**NOTICE OF A REGULAR MEETING
BONDURANT PLANNING AND ZONING COMMISSION
AUGUST 8, 2024**

TITLE: Resolution PZ-240808-23 - Considering approval of the site plan for Parcel 2024-102.

TITLE: Resolution PZ-240808-24 - Considering approval of the site plan for Featherstone Apartments.

FILE: H:\2023\2305313\2305313-SITE PLANS.DWG
DATE PLOTTED: 6/28/2024 3:39 PM
PLOTTER: HP DesignJet 5000PS
PLOTTER: HP DesignJet 5000PS

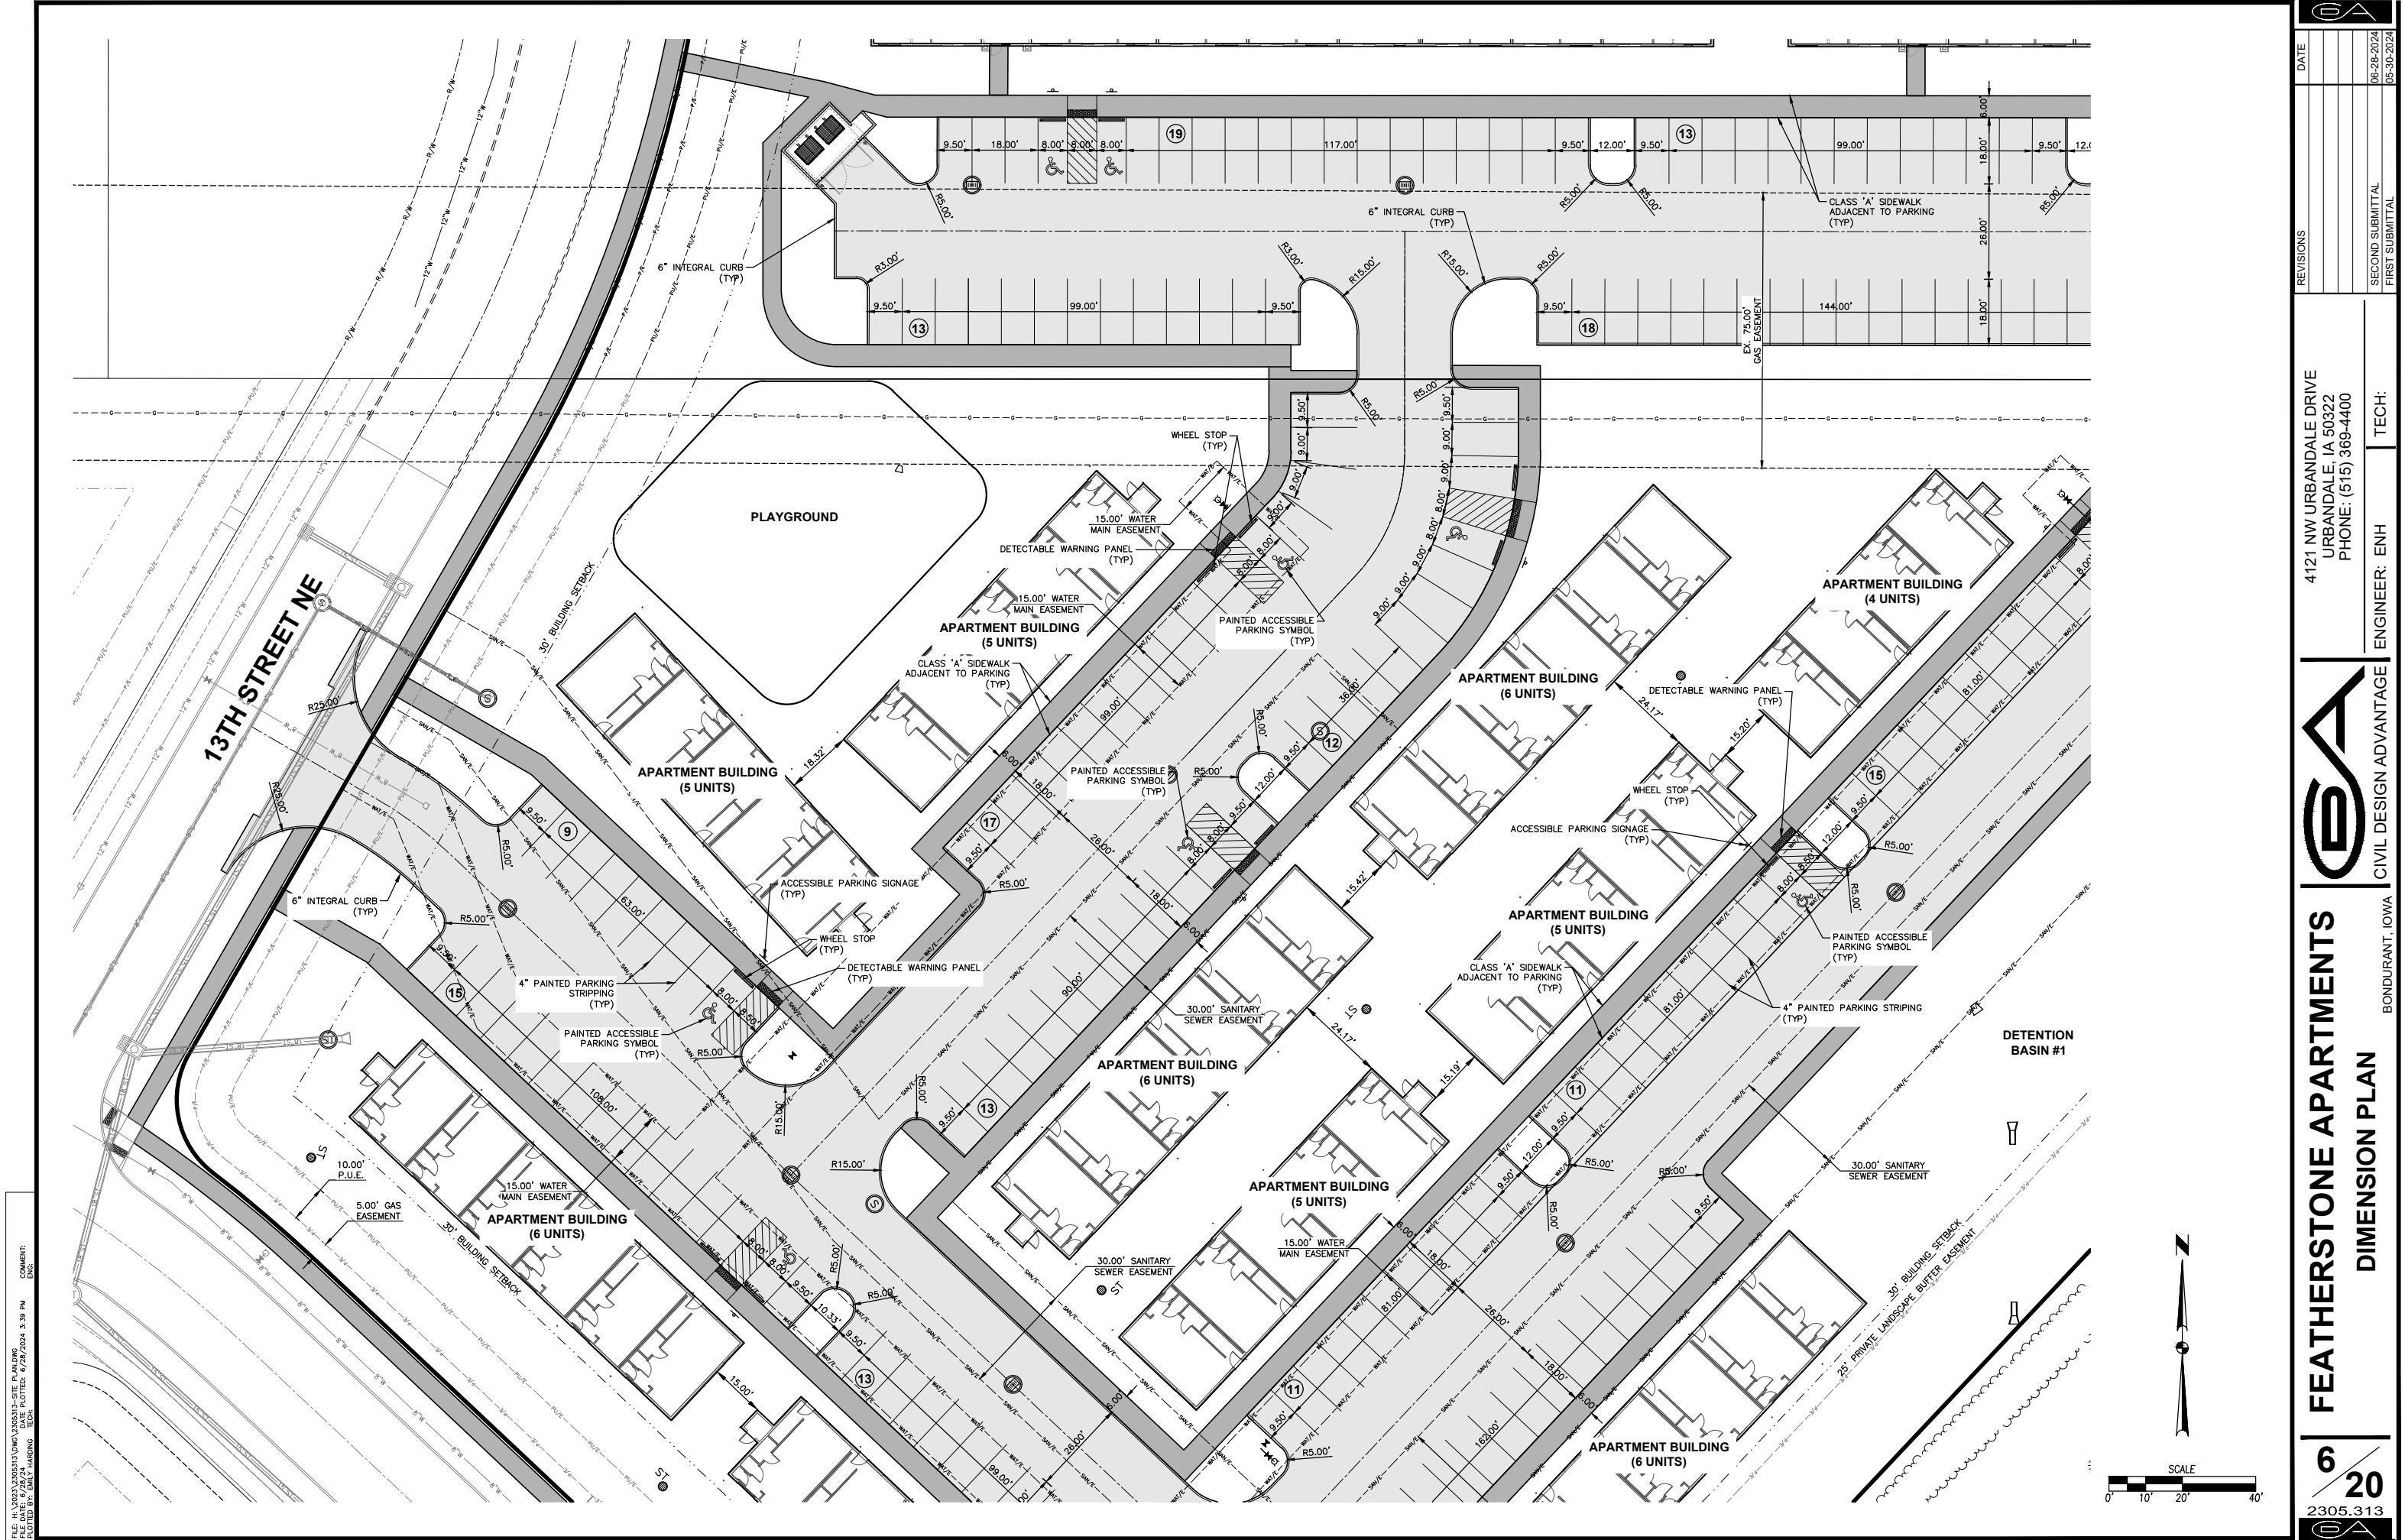
- The site plan does not show the correct road proposed alignment of 16th Street NE (AKA NE 86th Avenue) intersecting with Highway 65. The proposed draft intersection realignment route shown in the 2021-approved PUD Conceptual Plan and the 2021-approved Preliminary Plat has since changed per the City's further investigation of traffic safety in this area while also factoring in feedback received from the Iowa Department of Transportation. The Bondurant City Council hired Veenstra & Kimm in August 2022 to create a conceptual design of the proposed relocated intersection area well in advance of this proposed FY2028 street construction project, where the updated draft route cuts further south than what the developer is proposing on the attached site plan. The developer has known of this updated draft alignment since 2022 and is referencing the outdated proposed intersection alignment in its submitted plans.

1. Public Works - reviewed and all comments have been addressed, except for the following: the site plan does not show the correct road alignment of 16th Street NE (AKA NE 86th Avenue) intersecting with Highway 65.
2. Engineering – reviewed and all comments have been addressed, except for the following: the site plan does not show the correct road alignment of 16th Street NE (AKA NE 86th Avenue) intersecting with Highway 65.

Staff recommends tabling the submitted site plan until the correct road alignment of 16th Street NE(AKA NE 86th Avenue) intersecting NE Hubbell Avenue is shown.
